SUBJECT: Response to TAC comments  
Site Plan Application for a Site Redevelopment  
2255 Lafayette Road

# PROPOSED RETAIL MOTOR FUEL OUTLET SITE REDEVELOPMENT PLANS

ASSESSORS MAP 272 LOT 3  
2255 LAFAYETTE ROAD  
PORTSMOUTH, NEW HAMPSHIRE

GRADING &  
DRAINAGE  
PLAN

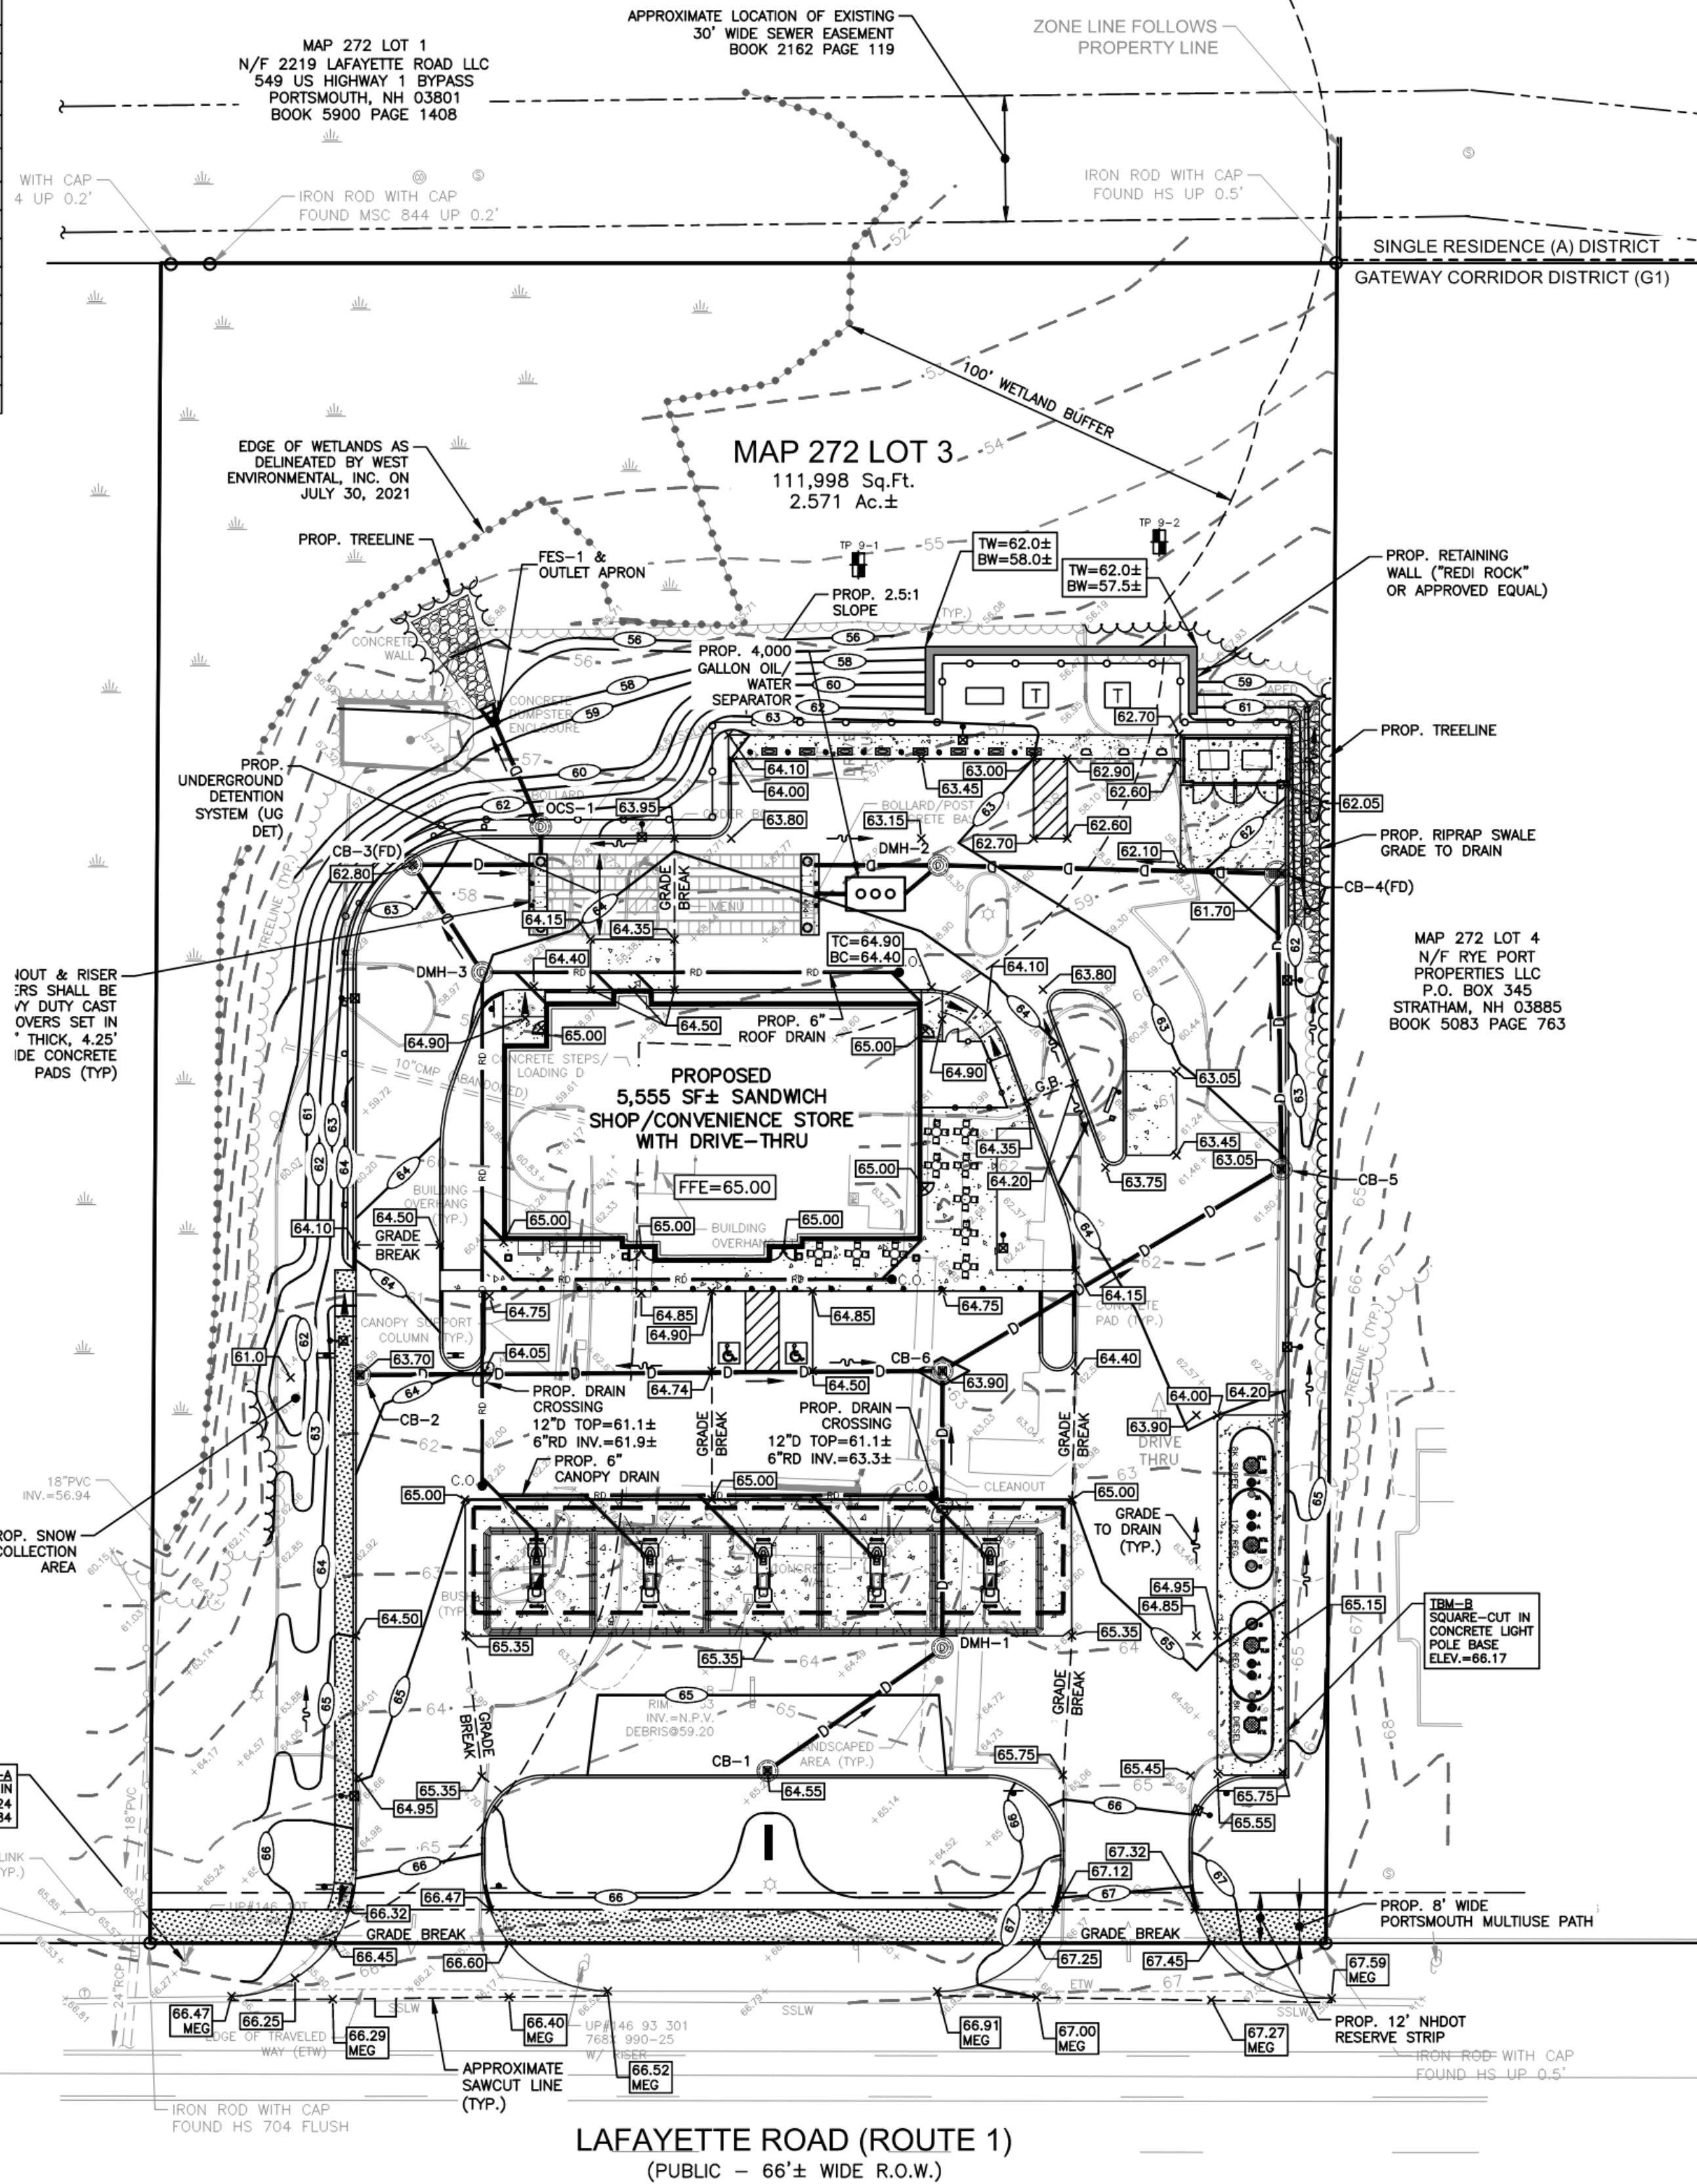
- 1. The OCS HDPE flow control tee outlet structure should have at least 3 SS straps holding it. Also, there should be no or virtually no sump in that assembly as the concrete structure itself has sufficient sump and it could keep animals from drowning. The OCS detail shows a 24" opening in the concrete top for a 32" manhole cover. The opening should be 30" for entry like a standard manhole, not 24". You should specify the distance required from the open top of the tee to the underside of the manhole top to ensure enough flow can enter the tee in peak flow conditions.*

- 3. Please show the multi-use path with shading so we can see it clearly and confirm that there are no physical obstructions in the way. Please confirm it will be graded at no more than 1.6% cross pitch and that it extends from property line to property line.*
- Response:** Shading has been added to the added to the multi-use path on the Site Plan and spot shots have been added on the Grading and Drainage Plan to show the path is graded at no more than a 1.6% cross slope.

**Response:** The Outlet Control Structure (OCS) detail has been revised to include 3 stainless steel straps, reduce the sump within the flow control tee, and revise the structure opening size to accommodate a 32" manhole cover. The distance from the OCS rim elevation to the elevation of the open top of the flow control tee is approximately 4.7 feet, therefore, there will be no flow restrictions for runoff to enter the open top.

#### UTILITY PLAN

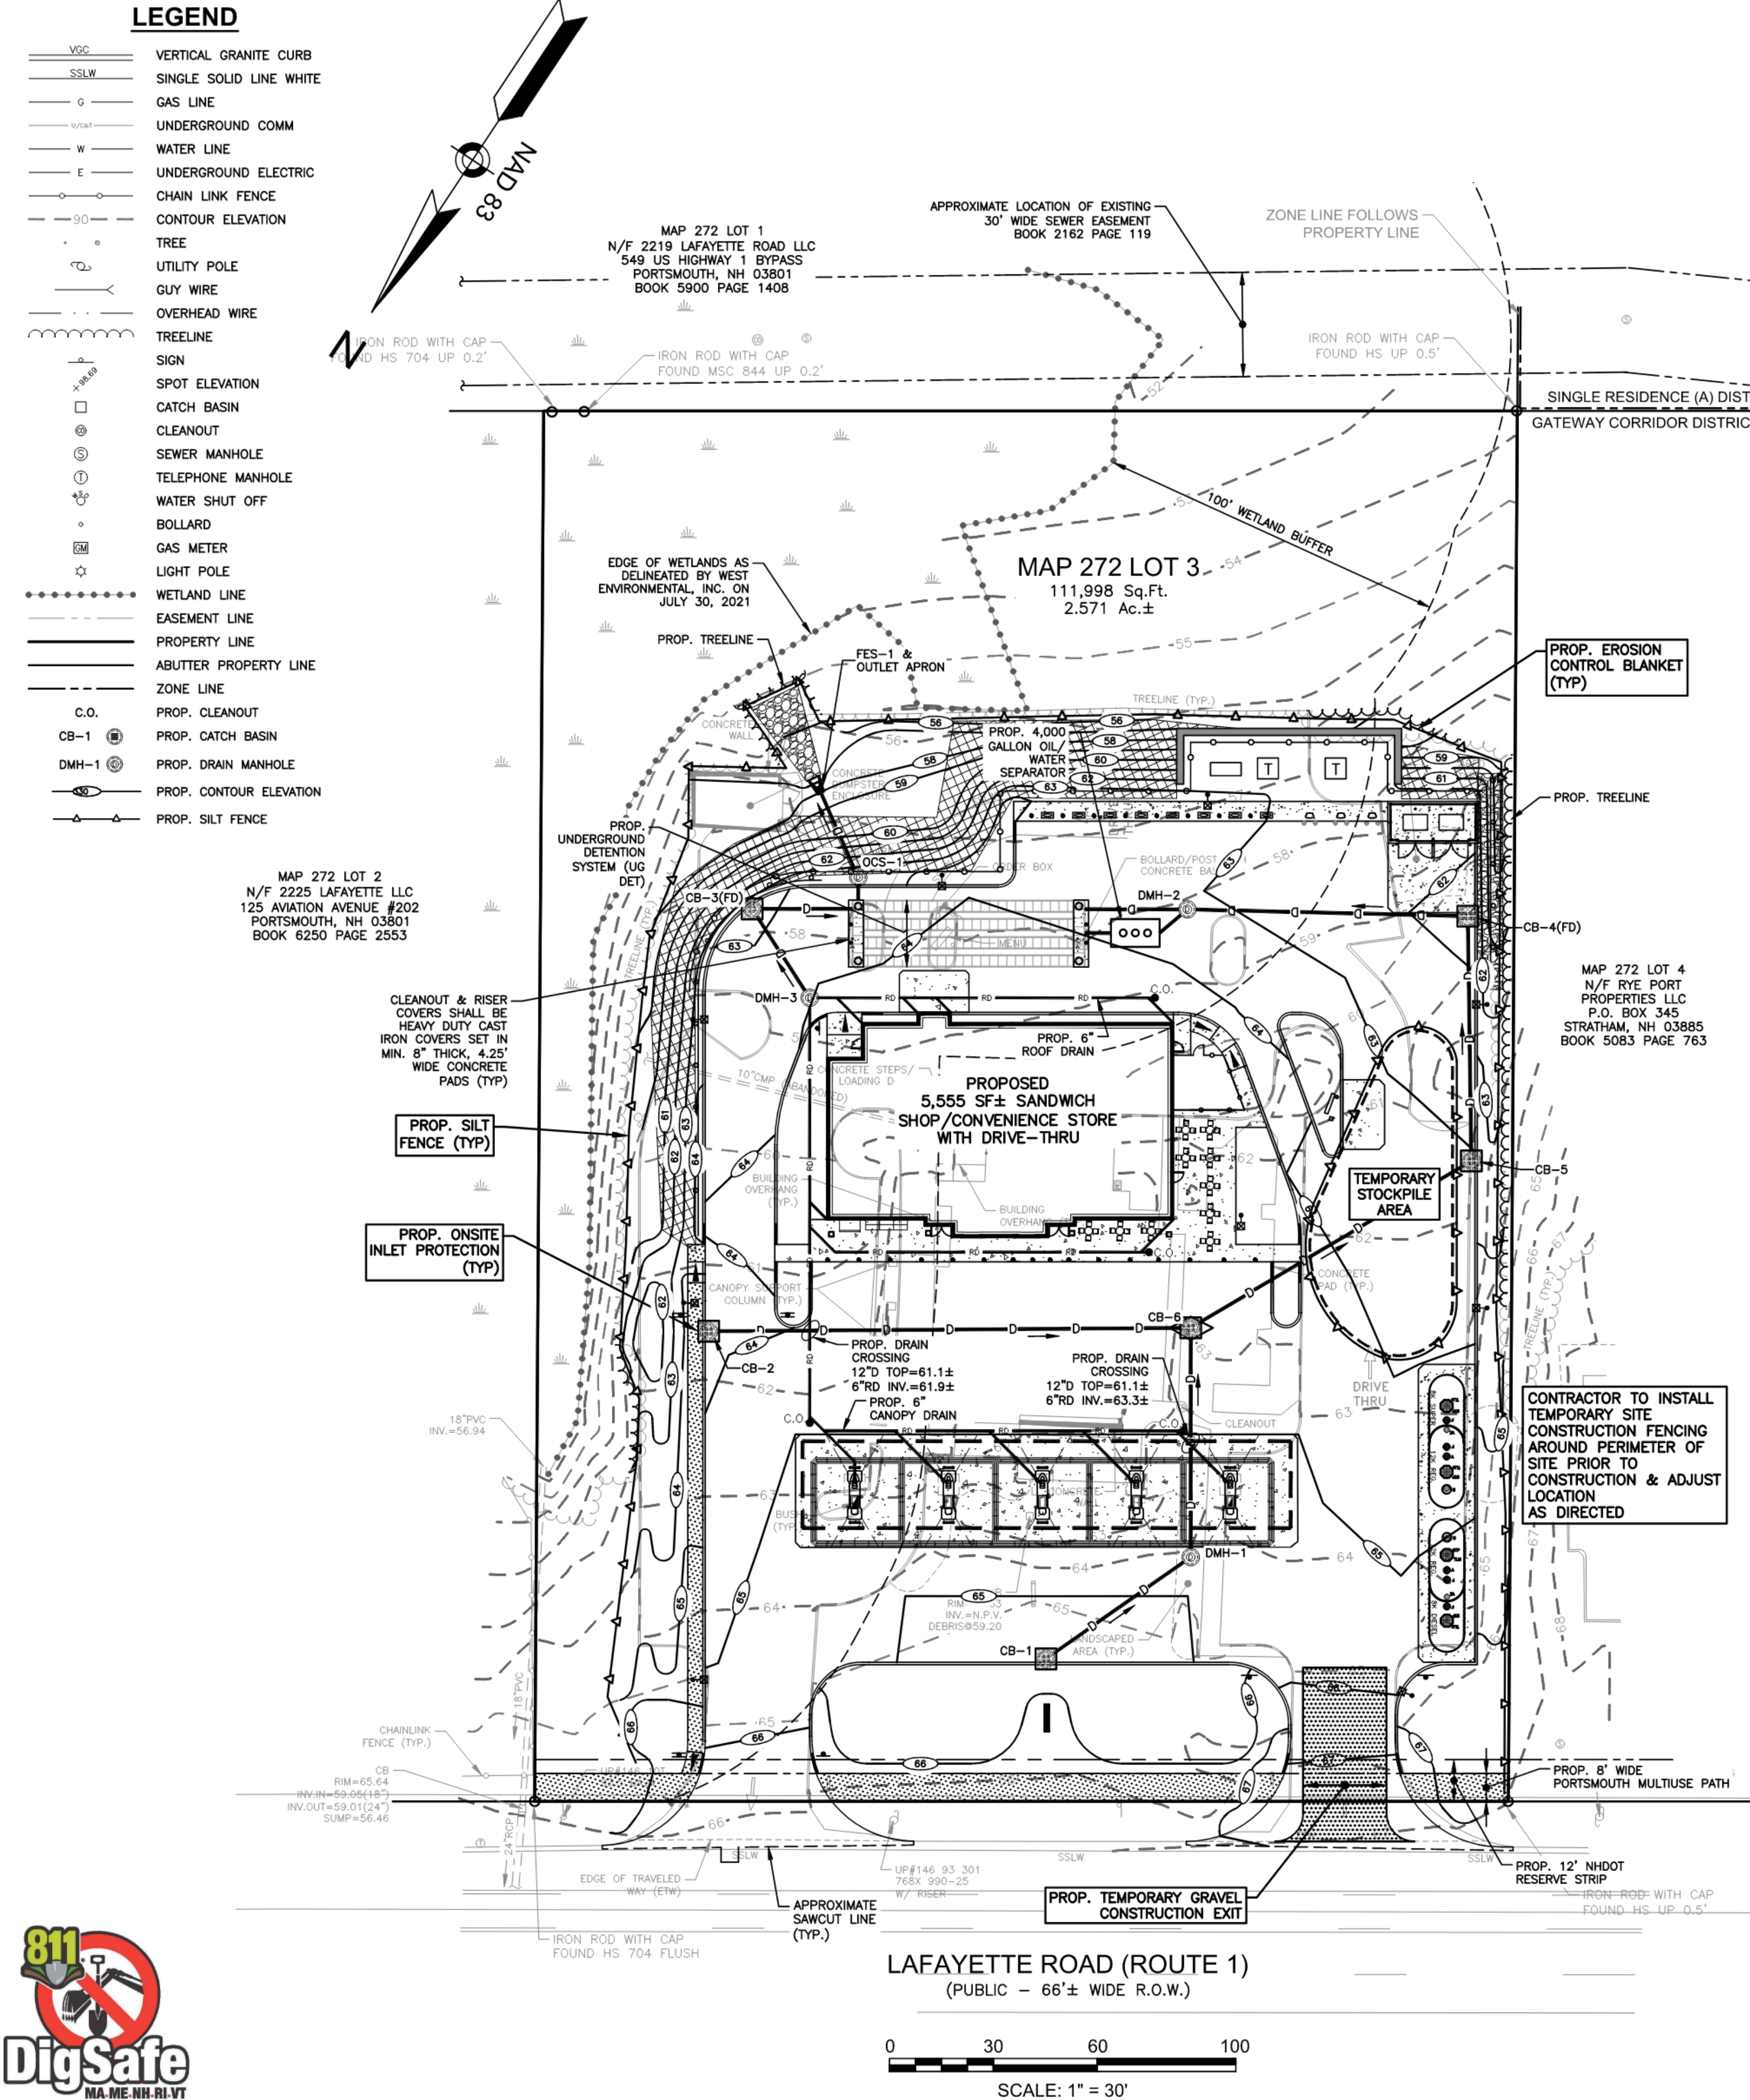
5. *Water shut off to be inside of a gate valve box if the shut off is located in the paved area.*  
**Response: The domestic line has changed to a domestic/fire protection line. The new water shutoff is proposed near the eastern building wall.**

6. *Existing water line will need to be abandoned at the main prior to demolition if it is not being reused. Existing service is 1.25" copper. CTS water service will need tracing wire installed, contact Water Dept. for information.*

12. *Please provide variance info on the plan set.*  
**Response: The date the variances were granted has been added to the Site Plan.**
13. *Commercial buildings greater than 5,000 sf require fire sprinkler systems.*

**Response: A note has been added that the existing water service should be abandoned at the main.**
7. *Stormwater maintenance plan will be required.*

**Response: A fire protection water line has been added to the Utility Plan.**
14. *Remove the crosswalk in the back.*  
**Response: Per discussions with Tesla, an accessible space with connection to the building sidewalk is required.**
